Memorandum

Subject: **RACER Nodular Industrial Land - Response to U.S. EPA Comments from April 4, 2019 Site Meeting**

GHD Services Inc. (GHD) has prepared the following memorandum in response to United States Environmental Protection Agency (U.S. EPA) comments from the April 4, 2019 Site Meeting at RACER's Saginaw Nodular Land (Site) in Saginaw, Michigan.

figure 2
 MONITORING WELLS
 SAGINAW NODULAR INDUSTRIAL LAND
 Saginaw, Michigan

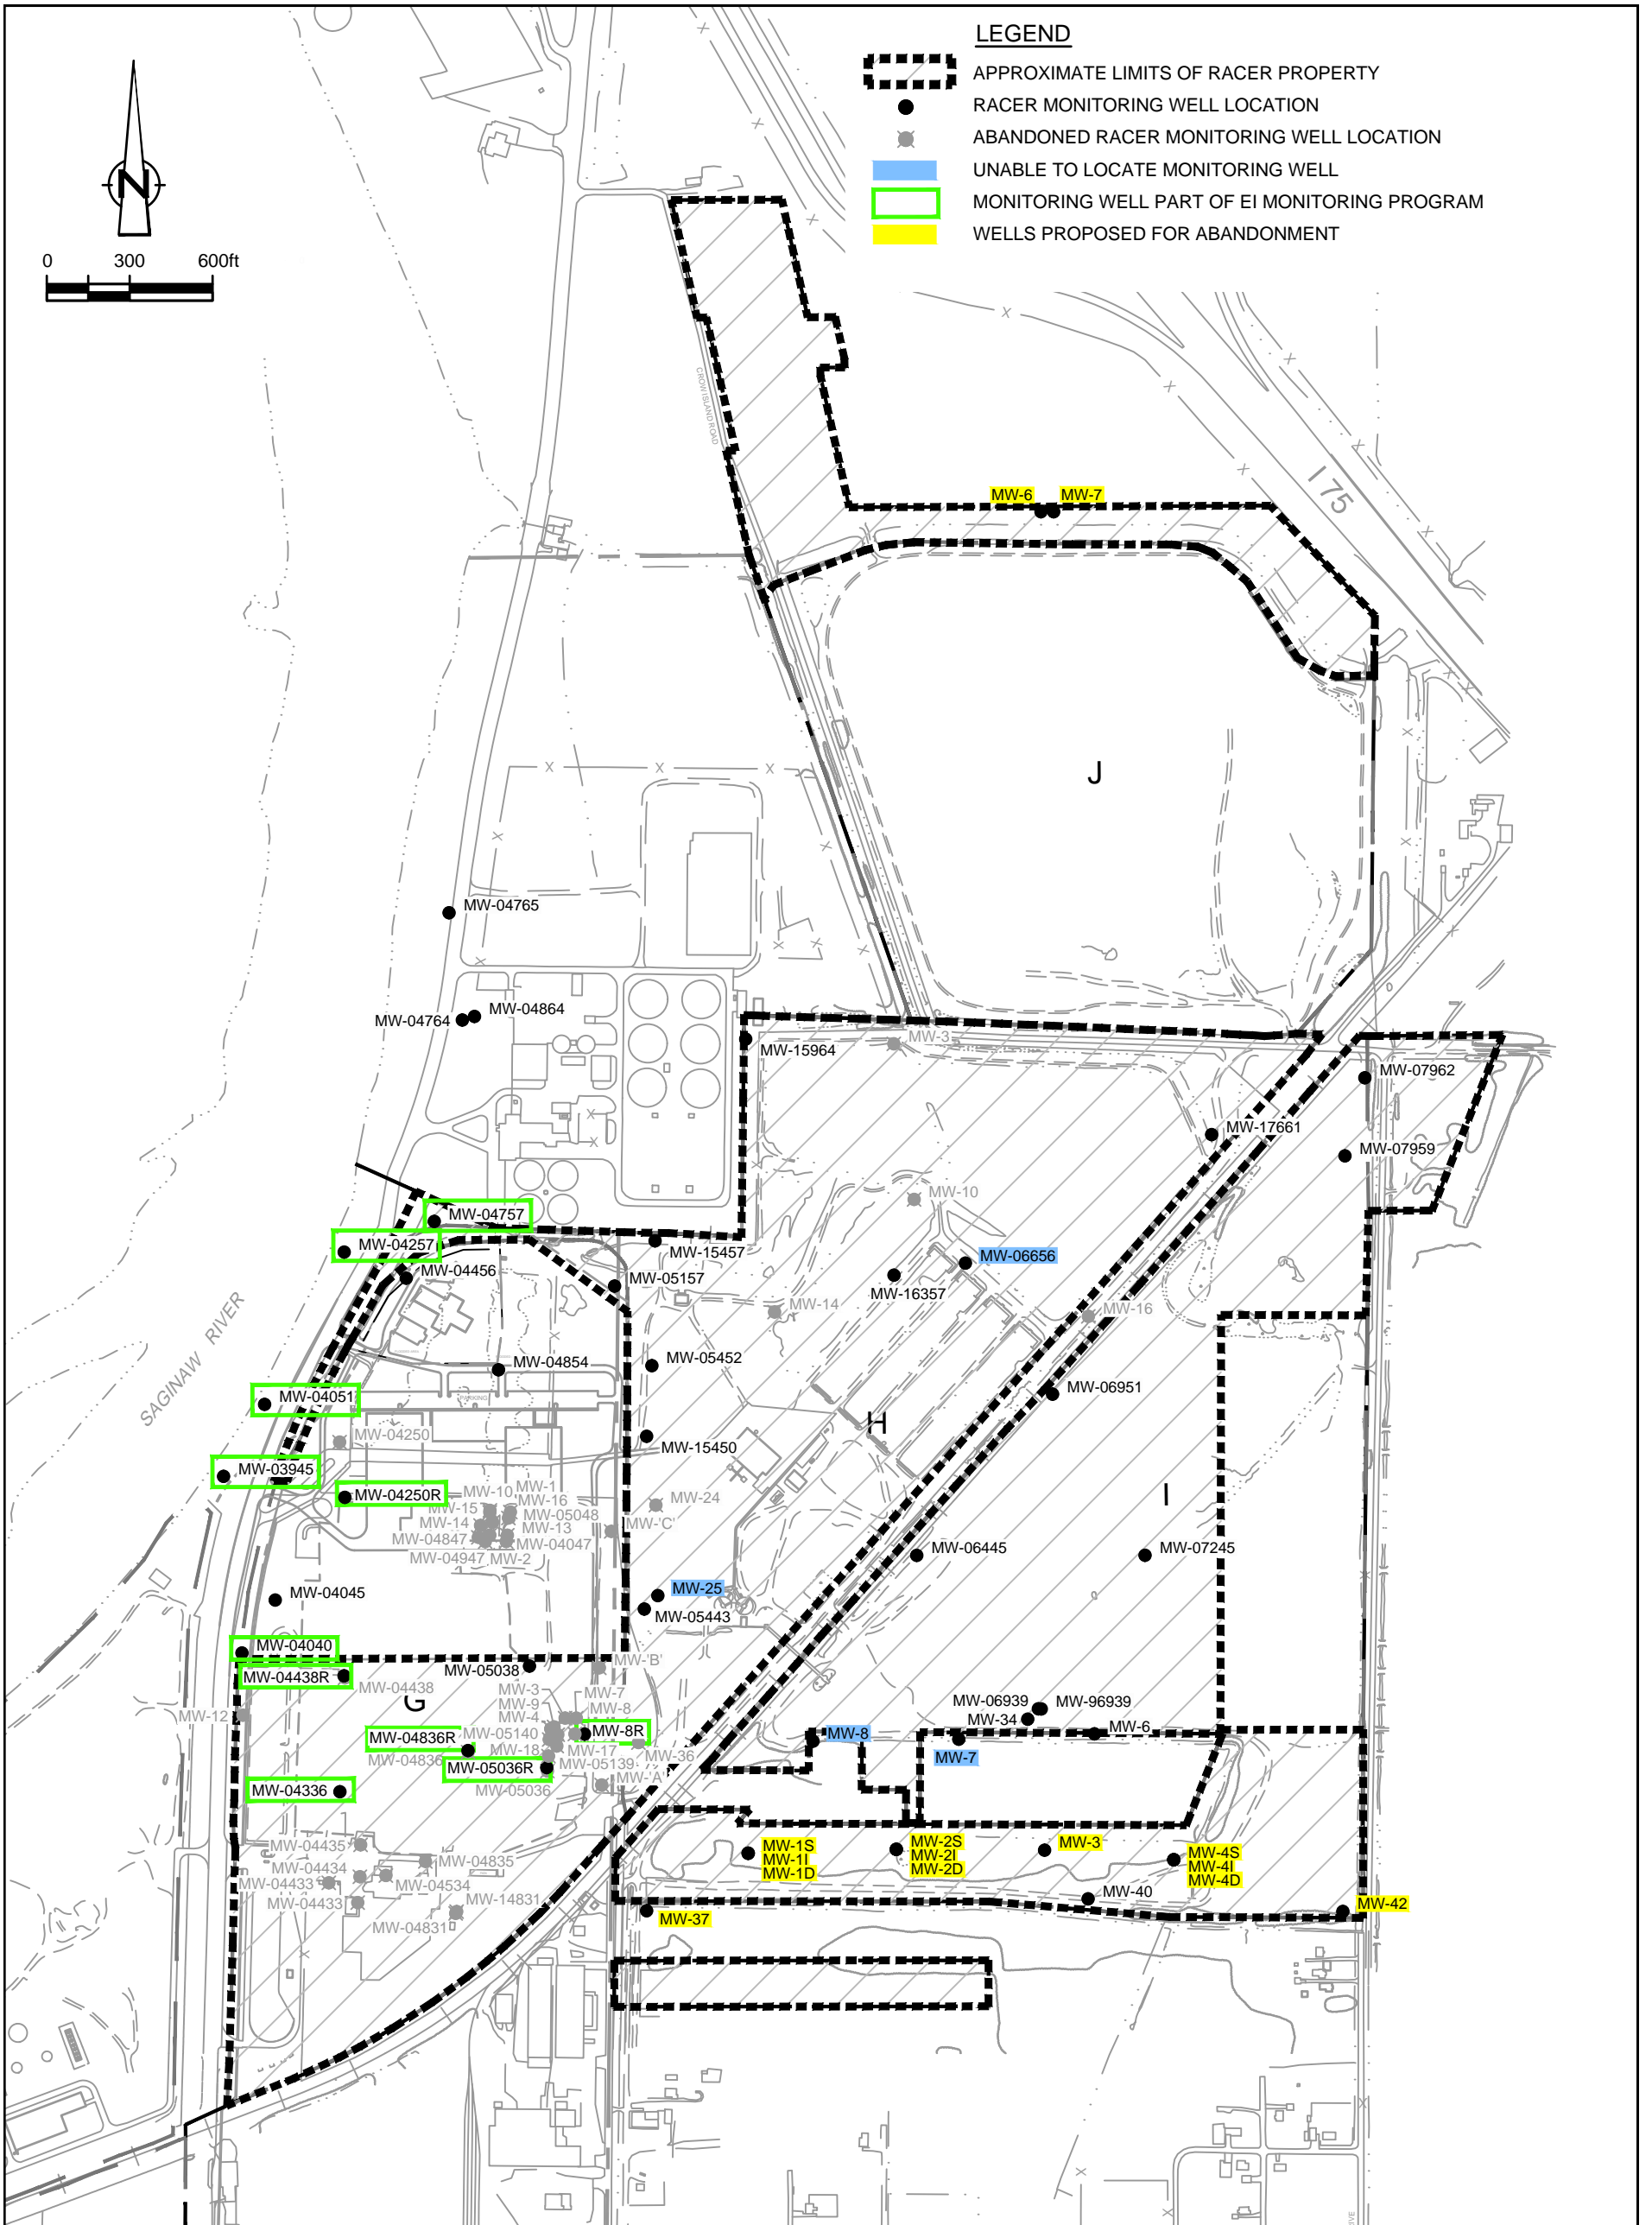
Review monitoring wells on property south of the clay pile and pending review, propose abandonment.

The following monitoring wells are located on the property south of the clay pile: MW-37, MW-1S, 1I, 1D, MW-2S, 2I, 2D, MW-3, MW-40, MW-4S, 4I, 4D, and MW-42. These wells are shown on Figure 2.

The only available data that is for locations MW-1S, MW-2S, and MW-4S. The locations were analyzed for ammonia (which were all non-detect) and pH (which ranged from 6.23 to 6.96 S.U.) during one event in 2001.

Based on the lack of historical operations in this area, review of available groundwater data, and lack of potential risk/exposure to groundwater in this area, GHD recommends that all the wells be abandoned.

Figure 1. Wetland Location Map

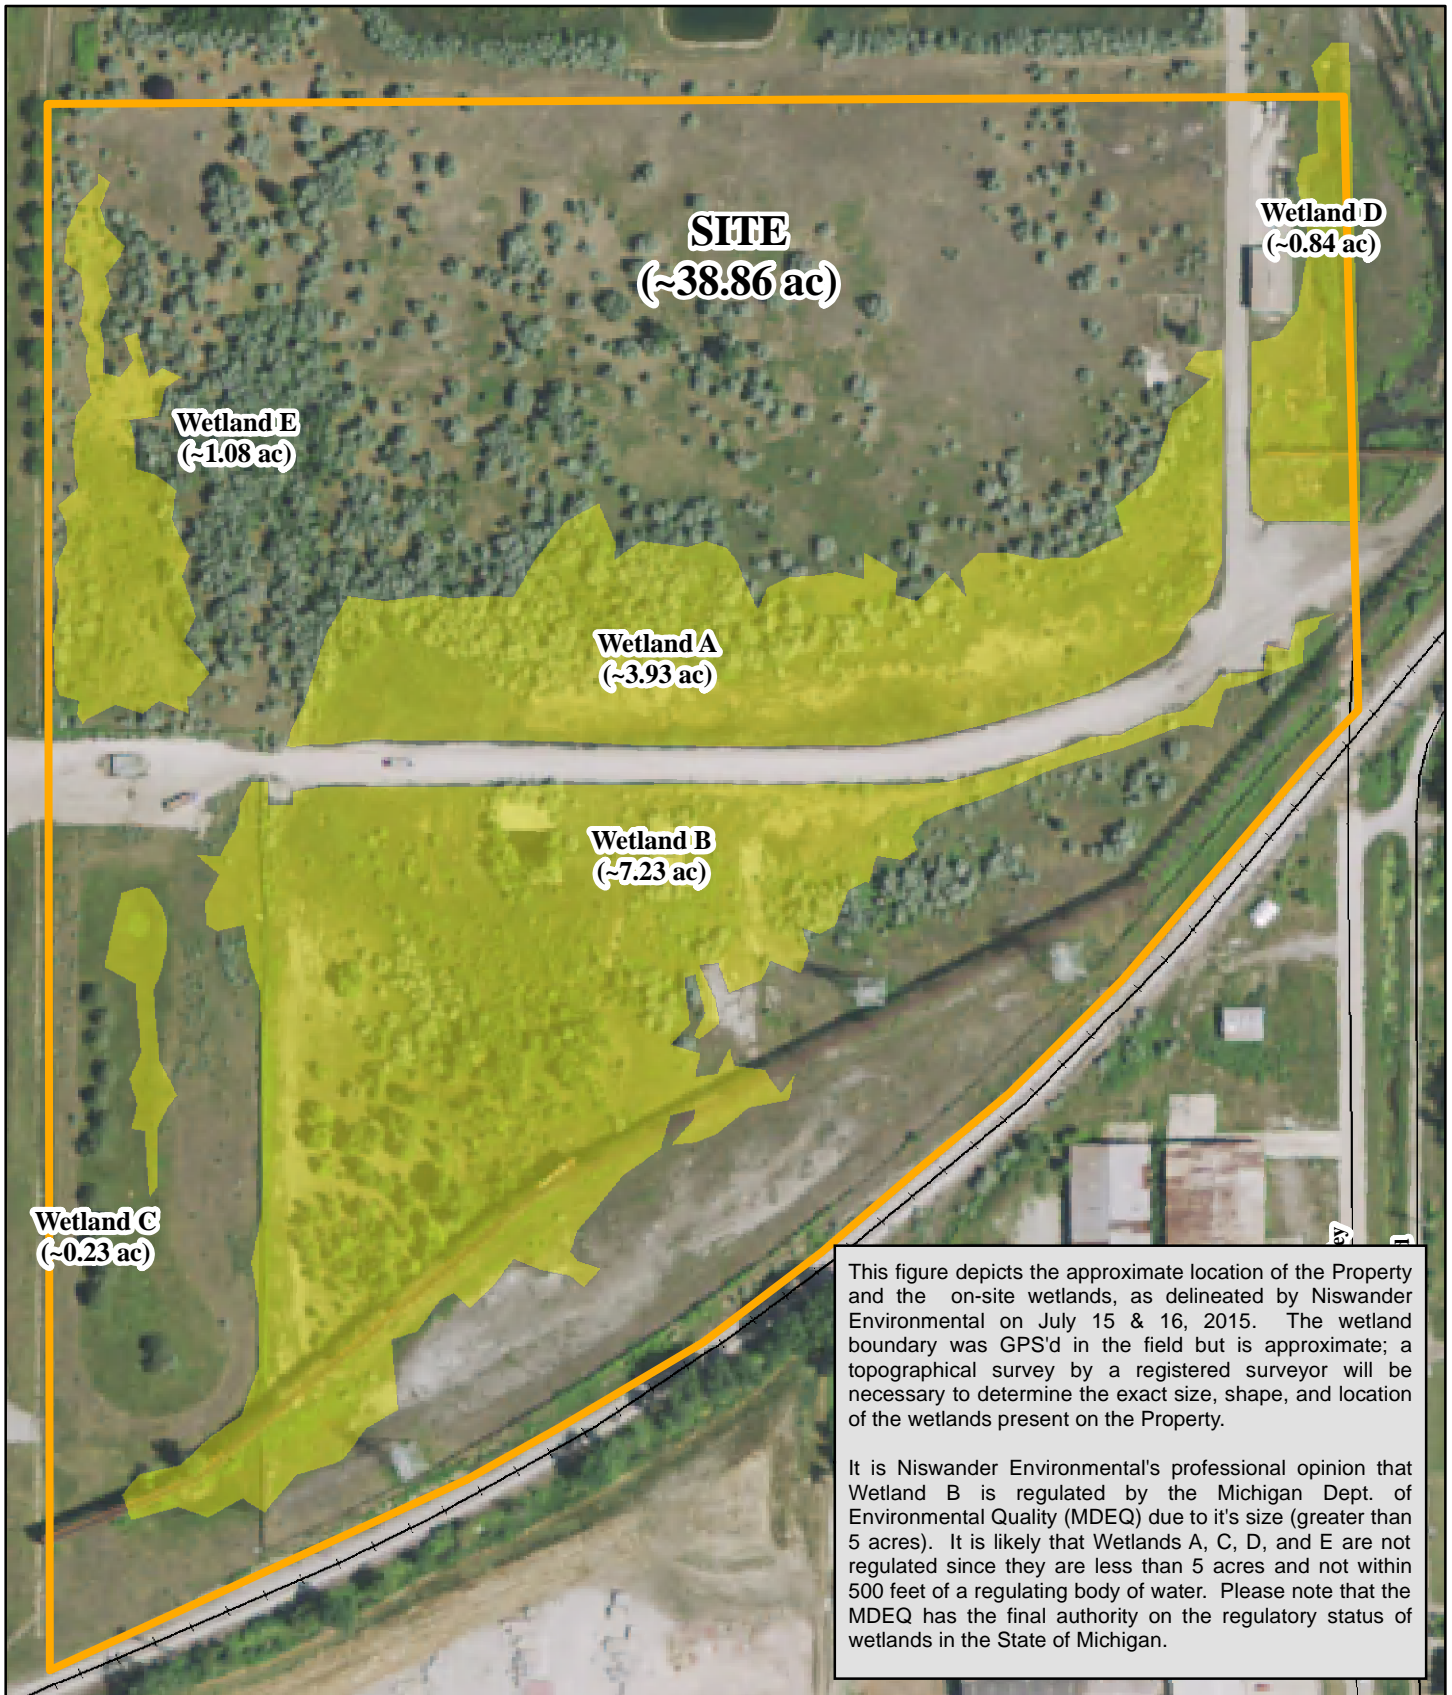
Provide wetland delineation for area south of former Nodular Plant.

A copy of the wetland delineation prepared by Niswander Environmental can be found in Attachment B. A copy of the letter can also be found on RACER's website at: <https://www.racertrust.org/Properties/Detail?Id=10040>
